## ***Interactive comment on “Benchmarking hydrological models for low-flow simulation and forecasting on French catchments” by P. Nicolle et al.***

**P. Nicolle et al.**

Received and published: 21 February 2014

Fig. 1. Models mean rank versus catchments

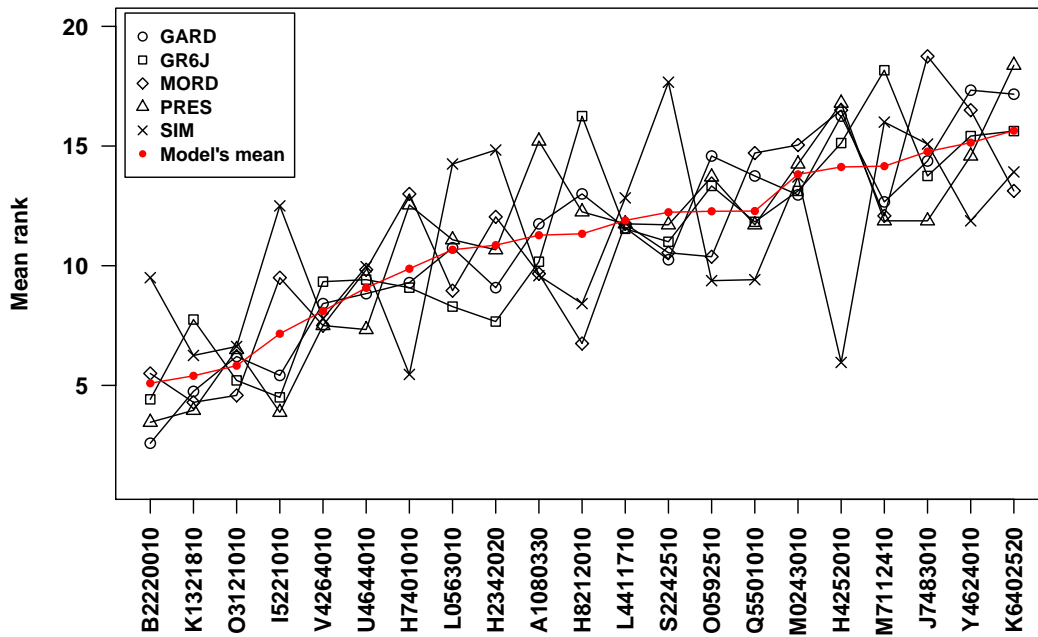
**RC: 2) The frequently repeated conclusion that “model performance depends more on the catchment than on the choice of model”, which is presented as the main outcome of the results as they are presented now, needs to be better supported. The analysis doesn’t prove this consistently e.g. by testing the degree of systematic ranking of models versus the degree of systematic ranking of catchments with the same approach.**

AR: This aspect is indeed not clearly shown in the article. The figure 1 shows the mean rank of the models for all the criteria and for each catchment. For each criterion, we ranked the performances of all catchments. Then, a mean rank is determined with the rank of the criteria. We see there is a general trend whatever the model, even though there is some large spread for some models. We will better discuss this aspect in the article.
